From: Graham Nicolls [REDACTED]
Sent: 11 August 2021 10:46
To: Kathryn Welch <Kathryn.Welch@arun.gov.uk>
Subject: RE: 54 Tarrant street Arundel

From: Karine Suhrbier [REDACTED]
Sent: 19 April 2021 10:44
To: Conservation Officer <Conservation.Officer@arun.gov.uk>; Martyn White <Martyn.White@arun.gov.uk>; Andy Waite [REDACTED]
Subject: 54 Tarrant street Arundel

We would really appreciate your feedback on three different issues regarding the proposed remedial damp proofing works on our home.

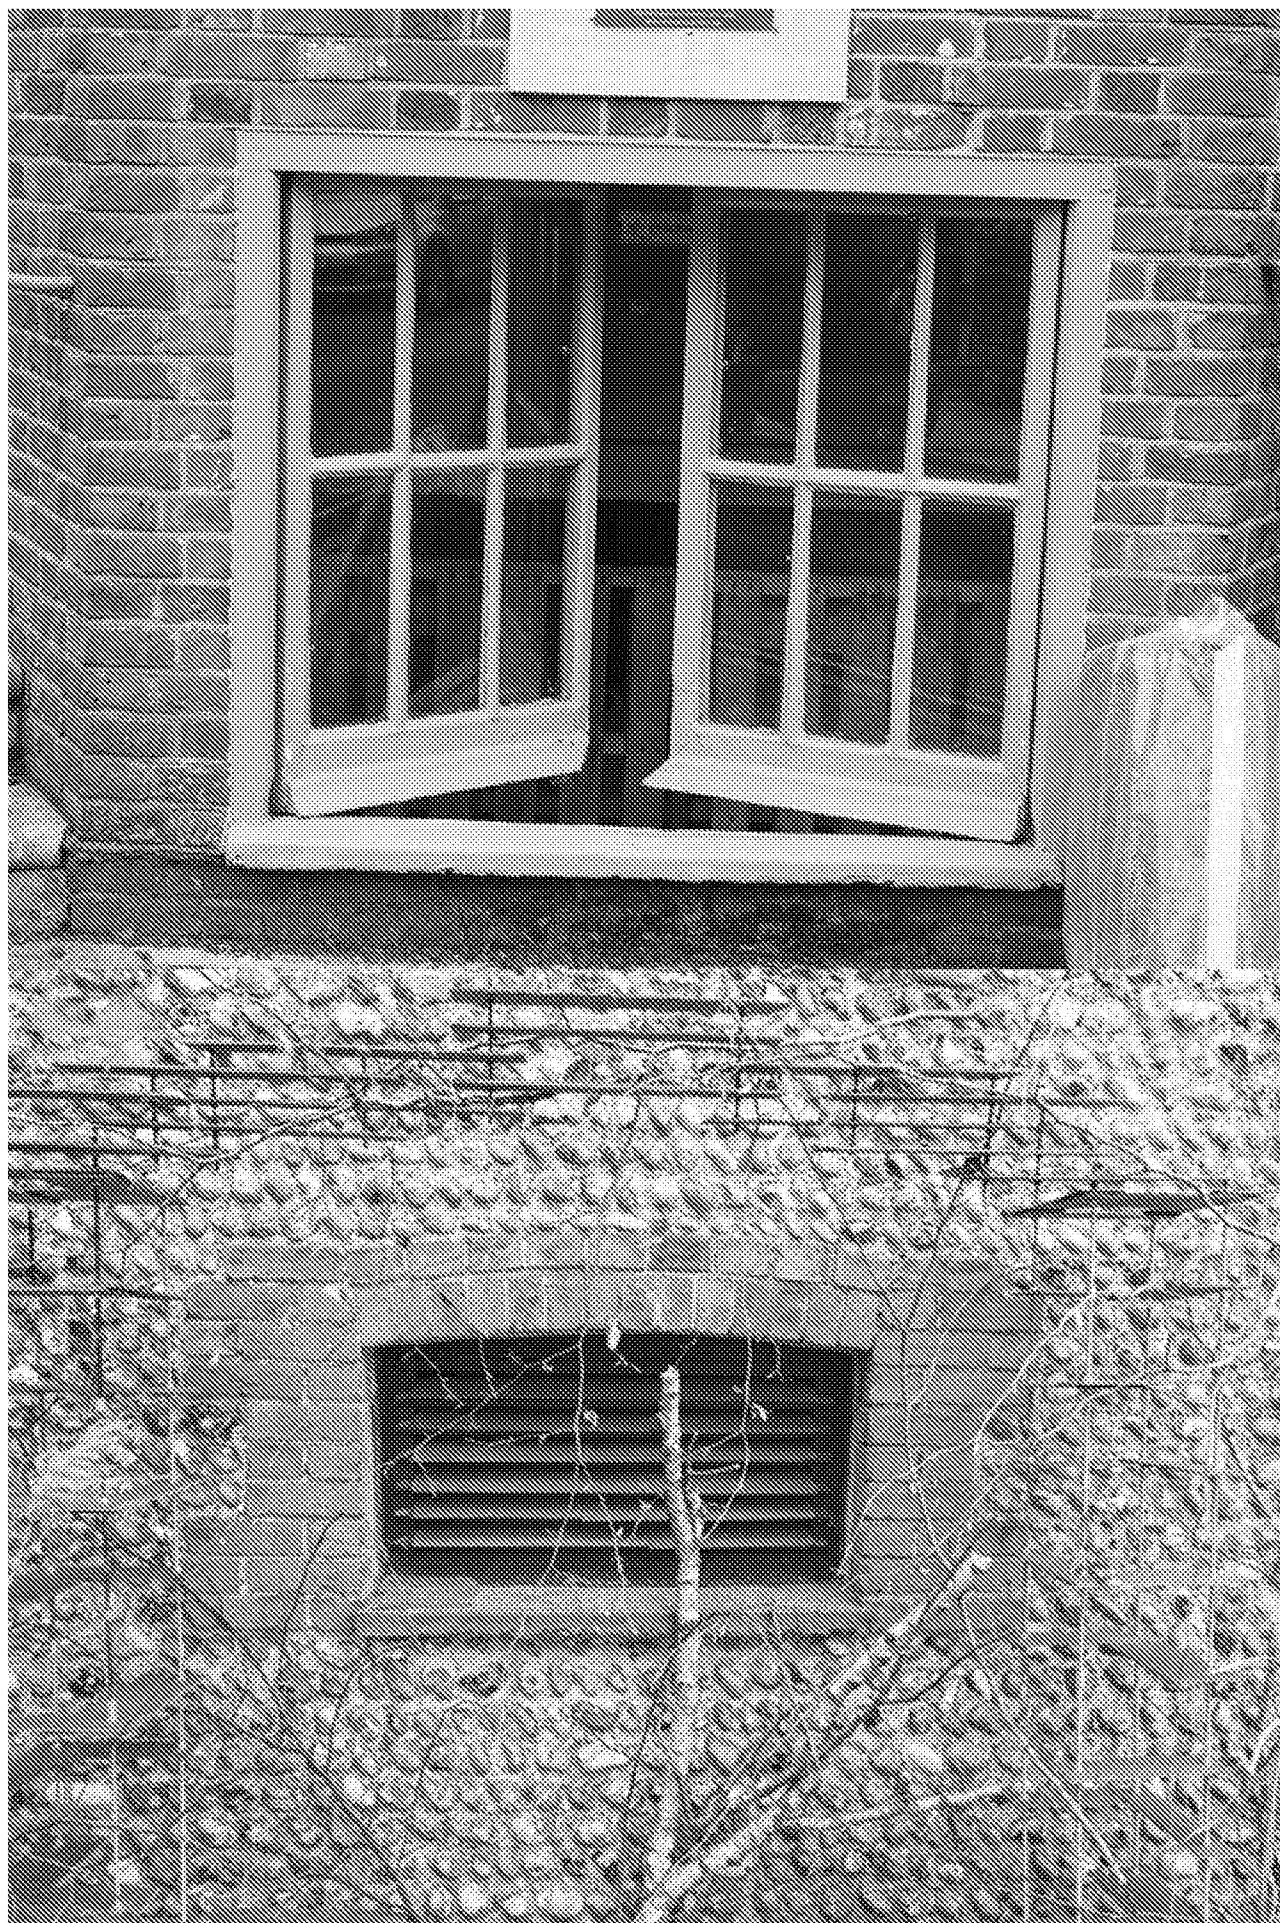
1. On 28th February, I sent an email replying to your previous one, asking about the dimensions of the glazing bars for the proposed double glazed, replacement of our top floor windows. For ease, I quote:

the glazing bars are 24mm x 44mm, and the windows will match the existing ones in all but that the new glazing bars are 2mm thicker than the old.

I have as yet not received any further communication about this. I wonder if you could give me your opinion on whether it is worth trying to get planning permission for them or if we should go for acoustic glass instead?

Double glazed units have been allowed in a limited number of properties in certain circumstances: the windows and the glazing were modern and did not affect the significance of the building. Ideally, the replacement windows would include single glazing as this is still best for the age and character of the listed building and area. However, as this proposal would only relate to the top floor, the impact would be lessened, and could be capable of support dependent upon the age of windows and the windows closely reflecting the existing, which I note you say would be the case.
